Summary of Items Discussed in 2/2019 APSEC Discussion Forum on 22 March 2019

10. PNAP APP-130

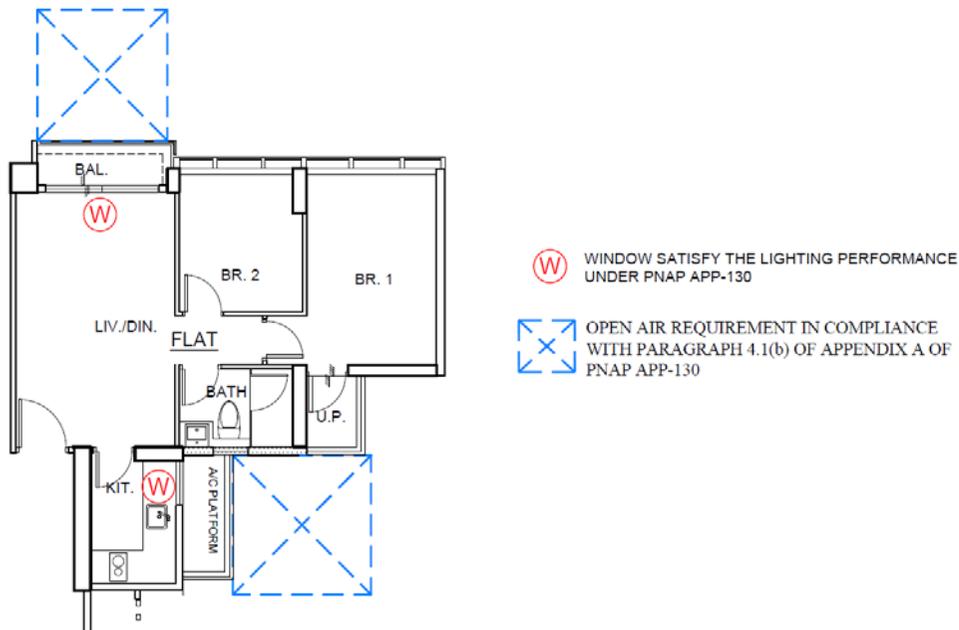
Paragraph 4.1(b) of Appendix A to PNAP APP-130 states that when a window can satisfy the UVA criteria (Diagram F), this window is considered to have met the performance standard of ventilation if, among others, the window faces into a clear and unobstructed area complying with at least the open air requirement. We understand that to face an open air does not necessarily require the window to open directly to open air. For instance, balcony sliding door satisfying UVA can still be considered to satisfy the ventilation criteria as illustrated below:

BD confirmed that the scenarios depicted in the sketch were acceptable provided that conditions in paragraph 4.1(a) to (c) of Appendix A to PNAP APP-130 would be complied with.

FS Code 2011 - Clause C8.1 (2015 rev.)

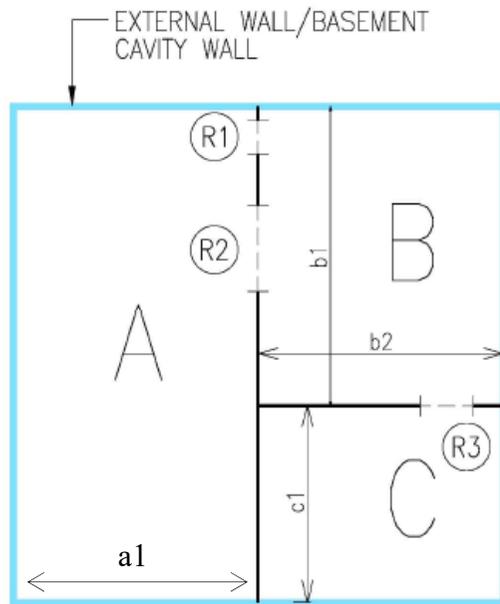
Clause C8.1 of FS Code 2011 reads “*Openings should not be formed at fire barriers forming part of a fire compartment as described in Clause C3.1 unless such openings are protected by fire rated doors or fire shutters having an FRR of not less than that of such fire barriers. If the total width of the openings is more than 25% of the length of the compartment walls concerned, the fire rated doors or fire shutters should have an FRR with regard to the criterion of insulation of not less than that of the fire barrier.*”

Please advise whether the calculation is correct.

BD advised that, in accordance with Item 7(d) of ADF 1/2012 held on 6.1.2012, in the context of Clause C8.1 of FS Code 2011, the plan lengths of all perimeter fire barriers forming a fire compartment would be taken as the denominator for assessing whether the width of the openings to be installed with fire shutters would exceed 25% of the concerned fire compartment and hence requiring such shutters to have insulation performance as well. For example, in a basement, the length of the enclosing walls on all sides would be added up to obtain the denominator, and only fire shutters making up over 25% of that denominator would need to fulfill the insulation requirement. On the other hand, in the situations of above-ground portions, external enclosing walls which would not be required to have prescribed FRR would not be counted towards the total plan lengths of a fire compartment.

In the quoted example,

In basement situation

For R1 and R2, FRR insulation would not be required if:

Compartment A: $(R1+R2) / [(b1+c1 +a1) \times 2] < 25\%$ and

Compartment B: $(R1+R2+R3) / [(b1+b2) \times 2] < 25\%$

For R3, FRR insulation would not be required if:

Compartment B: $(R1+R2+R3) / [(b1+b2) \times 2] < 25\%$ and

Compartment C: $R3 / [(c1+b2) \times 2] < 25\%$

In above-ground situation*

For R1 and R2, FRR insulation would not be required if:

Compartment A: $(R1+R2) / (b1+c1) < 25\%$ and

Compartment B: $(R1+R2+R3) / (b1+b2) < 25\%$

For R3, FRR insulation would not be required if:

Compartment B: $(R1+R2+R3) / (b1+b2) < 25\%$ and

Compartment C: $R3 / (c1+b2) < 25\%$

*external enclosing walls not required to have prescribed FRR

12. Access Panel to Air Duct

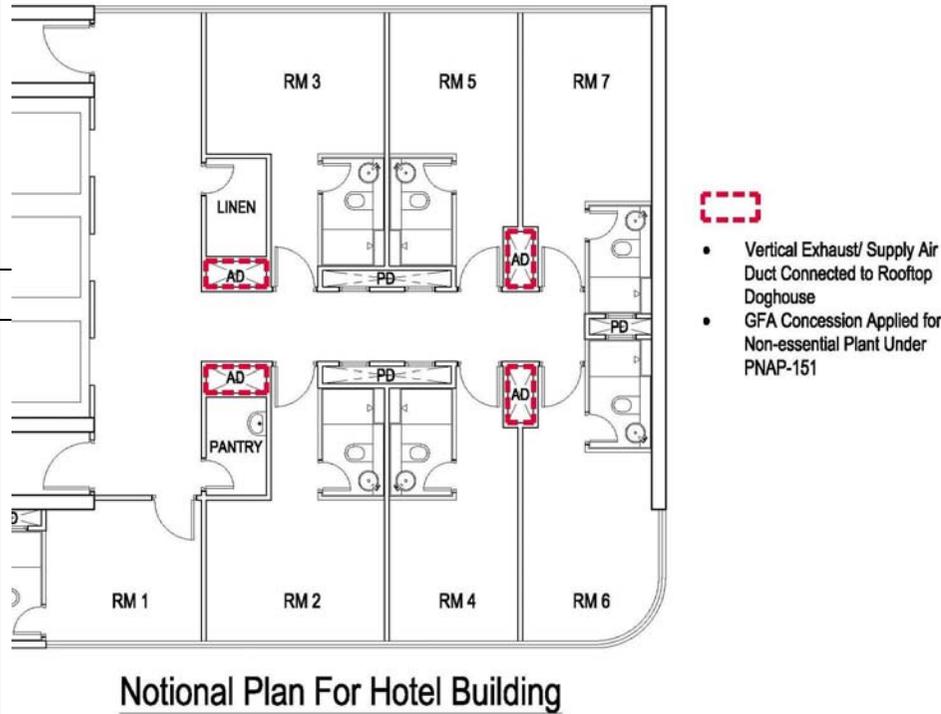
PNAP APP-93 specifies the requirements for pipe ducts and its access panels for drainage pipe duct. We understand that access panels for air

duct for non-mandatory plant rooms with GFA exemptions (under item 22 of Appendix A of PNAP APP-151) is not required. We note that such access panel to air duct serves no function at all. Please advise if our understanding is correct.

BD advised that PNAP APP-93 which set out the requirements for the planning and design of drainage works for new buildings might not be

appropriate for application to air duct. While the provision of access panels for air duct would not be a consideration for GFA exemptions under PNAP APP-151, the relevant requirements on provision of access for inspecting and cleaning/maintenance of ventilating systems under the Building (Ventilating Systems) Regulations should be observed.
